CONSTRUCTION PLANS
FOR
CREEKSIDE AT LORSON RANCH FILING NO. 2
STREET AND STORM SEWER CONSTRUCTION PLANS

SF 23-XX

V1_Construction Drawings (Plans_Profiles).pdf Markup Summary

STREET / STORM
 AKELA LANE
 STA 11+00 TO 14+78

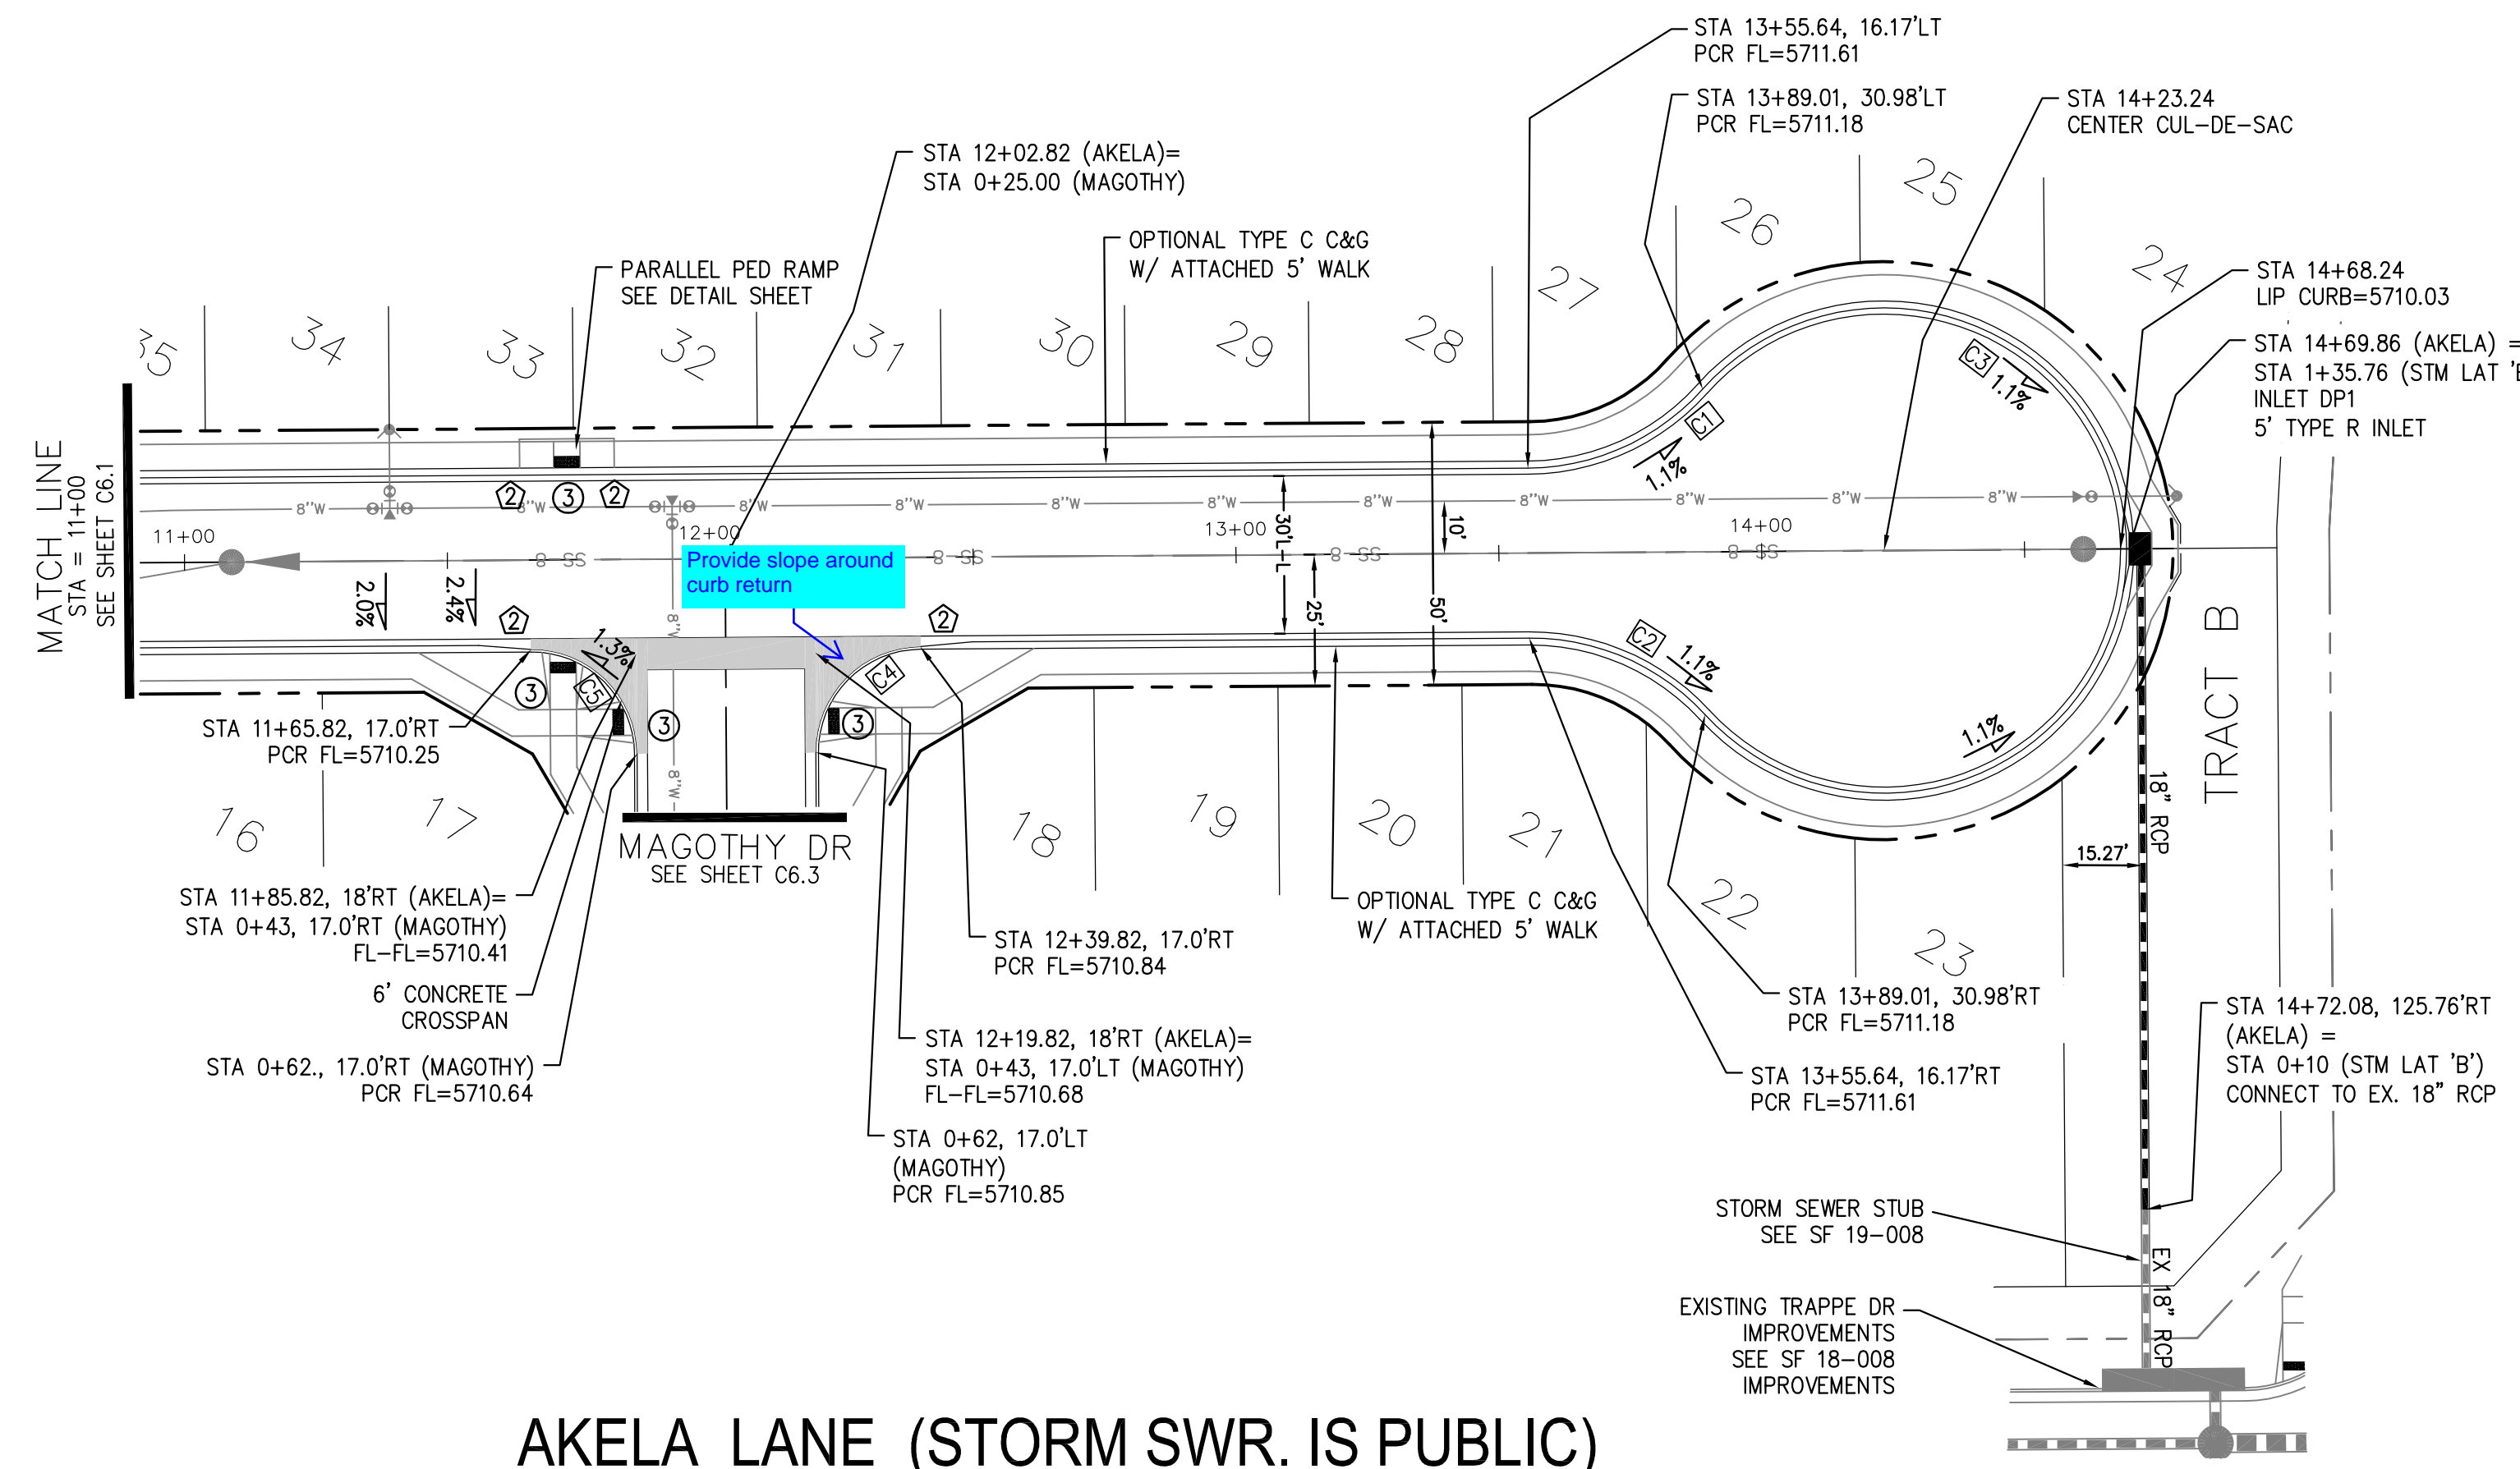
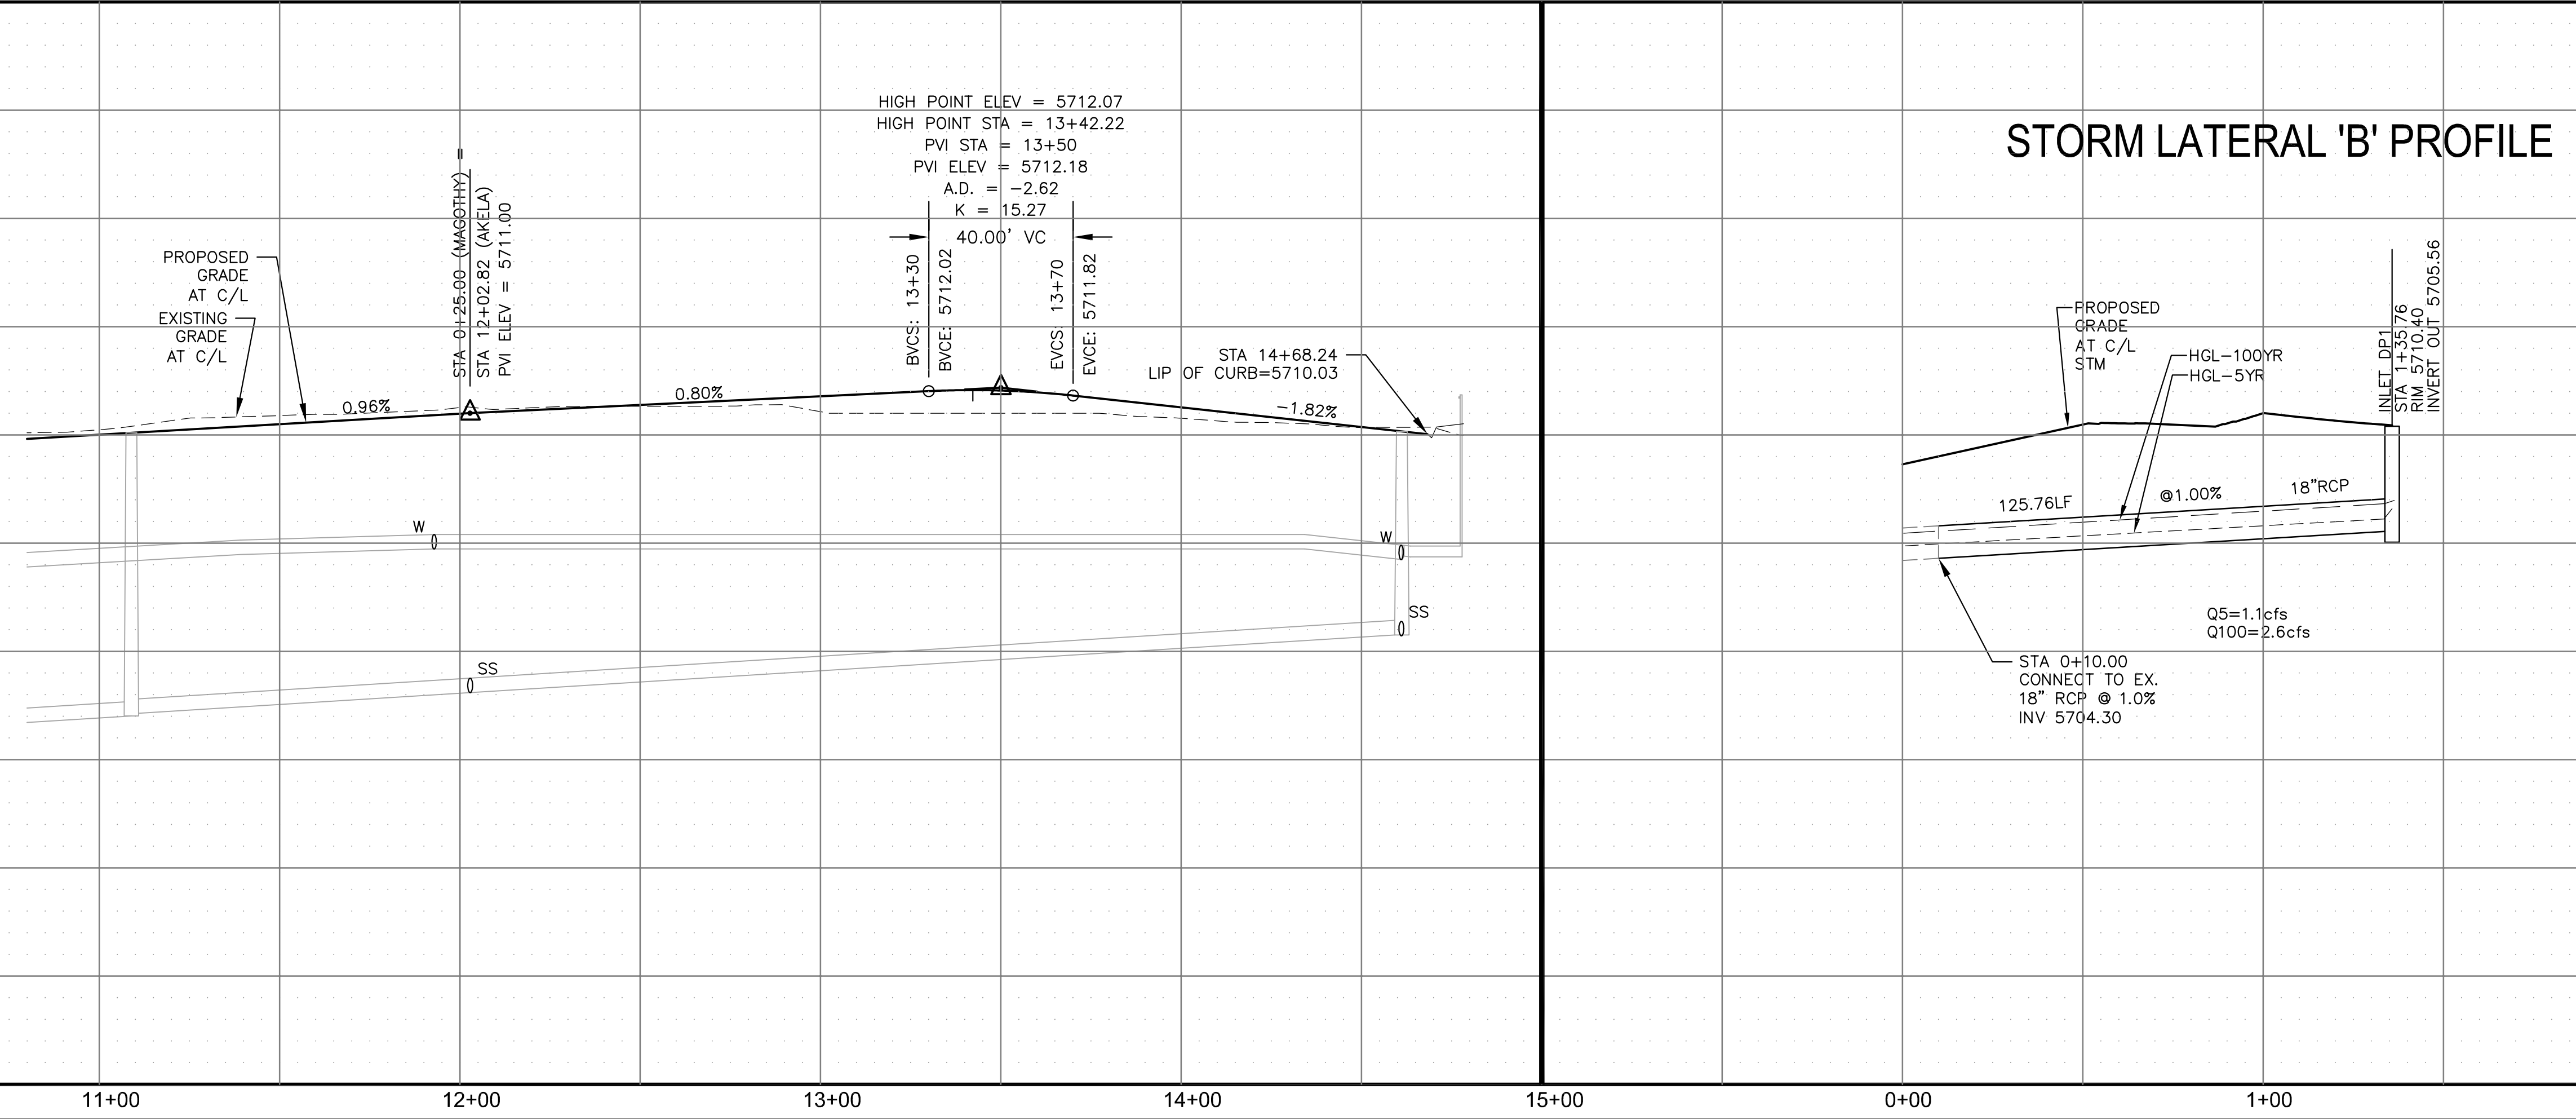
Provide slope around curb return
